**STAFF REPORT**  
**COMMUNITY DEVELOPMENT DEPARTMENT**

HEARING DATE: April 28, 2022  
 DATE: *Continued from: April 21, 2022*  
 TO: Planning & Zoning Commission  
 FROM: Sonya Allen, Associate Planner  
 208-884-5533  
 SUBJECT: H-2021-0099  
 I-84 + Meridian Road – CPAM, AZ  
 LOCATION: Generally located at the northwest corner of S. Meridian Rd. and I-84 in the southeast ¼ of Section 13, T.3N., R.1W.

Amendment to the Comprehensive Plan Future Land Use Map (FLUM) to change the future land use designation on 33.13-acres of land from Mixed Use – Community (MU-C) to Mixed Use – Regional (MU-R); and annexation of 18.30-acres of land with a C-G (General Retail and Service Commercial) zoning district.

Figure 3A from City of Meridian Comprehensive Plan. Note the focus on roadway frontage that transitions and integrates uses, and the open space amenities both integrated and shared.

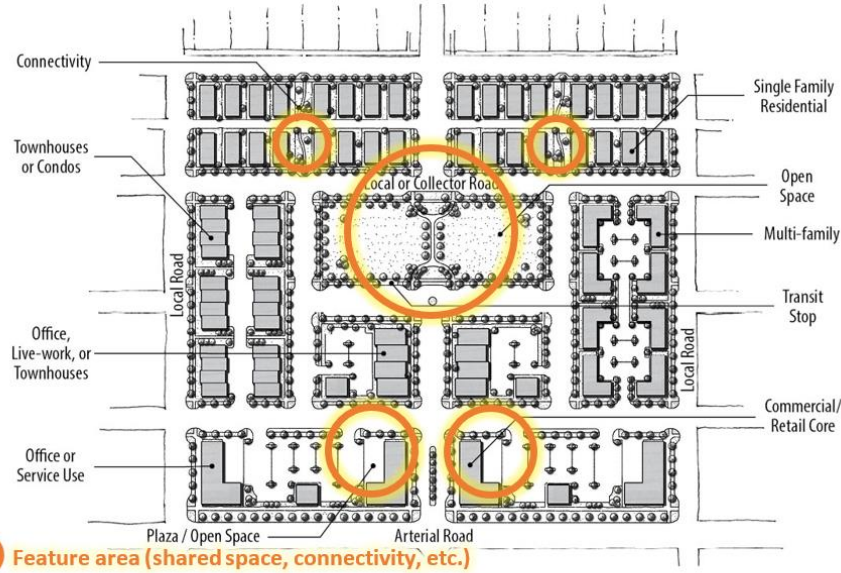
The proposed site plan does include a drive aisle located behind the large retail anchor, that in combination with a landscape buffer provides “a” transition to future residential to the west. This however is not the point of the mixed-use transition standards. As shown in the mixed use general and mixed use regional comprehensive plan figures (3A and 3D, below), roads are generally used to transition with fronting uses. These roads are intended to both integrate and to transition, and not to simply create a visual or physical barrier which is the antithesis of the purpose and intent of the mixed-use designation.

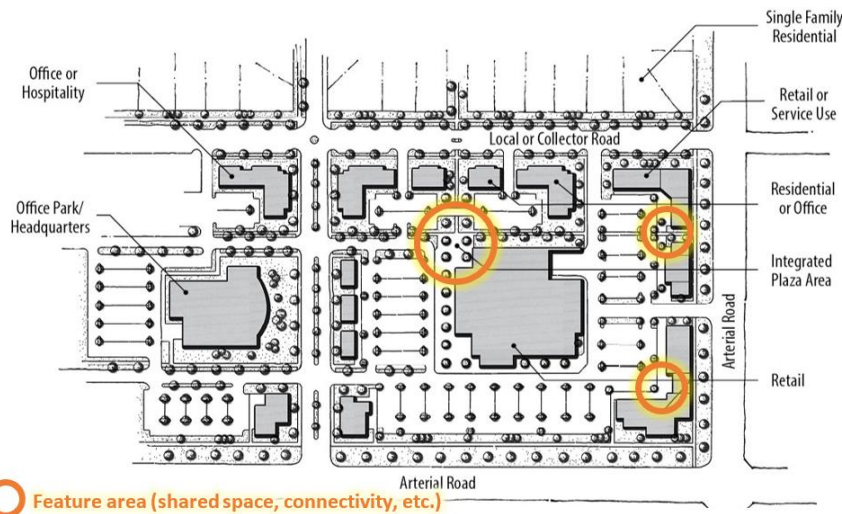
*The project does not comply with the provisions of the general mixed-use areas, either the purpose and intent, or with the most of the specific standards. The subject application requests Mixed Use Regional for a project entirely commercial and without any of the integration required in mixed use areas. This site and the one to the west are not integrated simply because an access point is provided; secondary access to the west would be required by staff for any modern project in the City. These connections reduce congestion, provide alternatives and redundancy, and to improve quality of life. NOTE: Staff recognizes that the Ten Mile Creek separates these two projects. However, both projects are turning their back to the Creek and not proposing to embrace it as an amenity that ties the project together. While it may be cost prohibitive to have several crossings of the Creek, it is critical that both pedestrian and vehicular crossings exist.*
